2CAN121602

SUBJECT: Supplemental Information
License Amendment Request to Revise the National Fire Protection
Association (NFPA) Standard 805 Modifications
Arkansas Nuclear One, Unit 2
Docket No. 50-368
License No. NPF-6

Supplemental Information – ANO-2 NFPA-805 Revisions

The simplified diagram below depicts the flow paths described above:

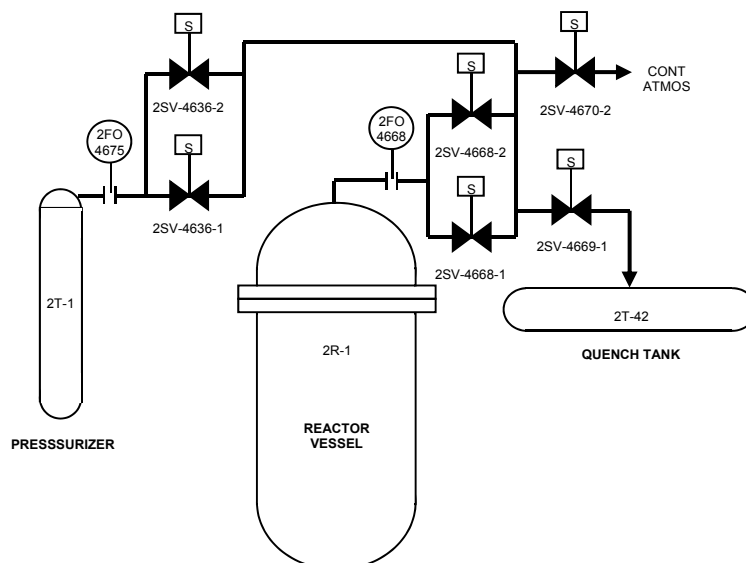
Modification S1-9 (2SV-4670-2 and 2SV-4669-1) – Inhibit switch credited in this modification; however, the change in risk due to this modification change is listed in Table 2 as “no more than minimal” because the change results in an insignificant change in risk.

To address the potential failure of the inhibit circuit for this modification, it should be noted that multiple valves are required to fail in order to meet the criteria for a small break loss of coolant accident (SBLOCA). The hot short probability used also considers the hot short duration terms provided in NUREG-7150. The following combinations of spurious operations are required for each flow path:

1. Through flow orifice 2FO-4675 spurious operation of either RCS vent valve 2SV-4636-1 or 2SV-4636-2,
AND
2. Through flow orifice 2FO-4668 spurious operation of either RCS vent valve 2SV-4668-1 or 2SV-4668-2,
AND
3. Through one of the RCS vent valves 2SV-4669-1 or 2SV-4670-2.

From NUREG-7150, the hot short probability is 1.763E-01 and the hot short probability for scenarios lasting greater than 7 minutes is 2.20E-03.

For the configuration above, the probability of an RCS leak as defined in the multi-spurious operation (MSO) report is $([2 \times (1.763\text{E-}01 \times 2.20\text{E-}02)]^2) \times [2 \times 1.763\text{E-}01 \times 2.20\text{E-}02] = 4.67\text{E-}07$. When this probability is combined with the frequency of a fire inside the cabinets in the MCR (4.28E-05/yr), the impact on the core damage frequency (CDF) is considered negligible in relation to the overall CDF as depicted in Table 2 of the Reference 1 letter.
